# Access Compliance Report

### (Curb Ramps)

Intersection ID: 10040527	Main Street: W_5TH_ST	Cross Street: N/A	Location: SW
ADA ID: 124F1D5411B7	Ramp Type: Perp	Initial Pass/Fail: Fail	Overall Compliance: No
Severity Score: 12.5			
Codes/Mitigation Info/Possible Solution		Field Measurements/Component Compliance

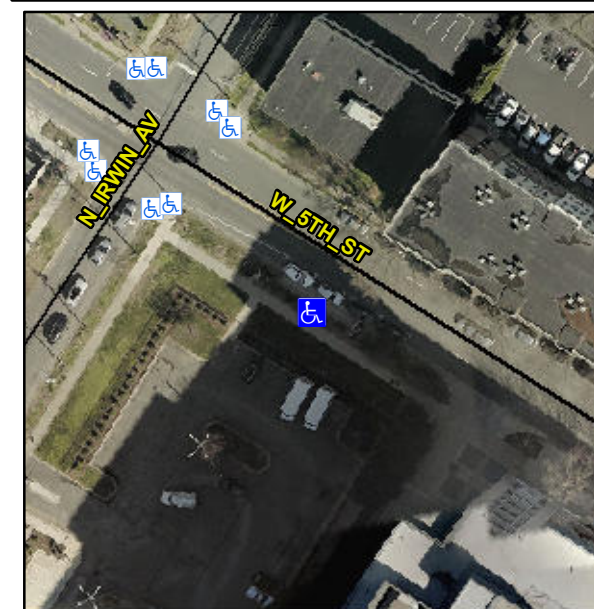
**Not Found, R304.5.3**

Compliance	Description	Data	Compliance	Description	Data
N/A	Ramp Length (in)	101.0	Yes	Ramp Slope (%)	7.2
Yes	Ramp Width (in)	60.0	No	Ramp XSlope (%)	6.4
N/A	Flare Type LT	N/A	N/A	Flare Type RT	N/A
N/A	Flare Slope LT (%)	N/A	N/A	Flare Slope RT (%)	N/A
N/A	Flare Traversable LT?	N/A	N/A	Flare Traversable RT?	N/A
N/A	Landing Length (in)	N/A	N/A	DWS Provided?	N/A
N/A	Landing Width (in)	N/A	N/A	DWS Contrast?	N/A
N/A	Landing Slope (%)	N/A	N/A	DWS Length (in)	N/A
N/A	Landing X Slope (%)	N/A	N/A	DWS Full Width?	N/A
N/A	Landing Curb? (Y/N)	N/A	N/A	DWS Offset (in)	N/A
N/A	Shared Landing?	N/A			
N/A	Gutter Ponding?	N/A	N/A	Gutter Slope (%)	N/A
N/A	Gutter Lip Ht (in)	N/A	N/A	Gutter X Slope (%)	N/A
N/A	Painted X Walk1?	No	N/A	Painted X Walk2?	N/A
	X Walk 1 Direction	To NE		X Walk 2 Direction	N/A
N/A	X Walk 1 Width (in)	N/A	N/A	X Walk 2 Width (in)	N/A
	X Walk 1 Slope (%)	1.5		X Walk 2 Slope (%)	N/A
	X Walk 1 X Slope (%)	5.9		X Walk 2 X Slope (%)	N/A

**Remove & Replace Entire Ramp.**
